GMS Textiles Ltd. (Extension)

Tansutrapur, Kaliakoir, Gazipur

14 November 2023

2. Observations

Observation-2: Discrepancies in as-built drawings (Dyeing Building -02).

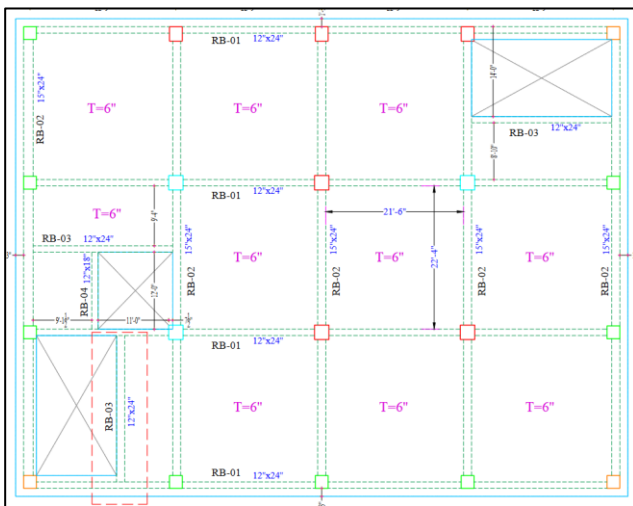
Description: During the inspection, mismatches were found between the onsite condition and the as-built drawing. On-site, 337 mm build-up was found in the toilet zone which is not mentioned in the drawing. The building engineer is required to survey the full structure and produce accurate as-built drawings.
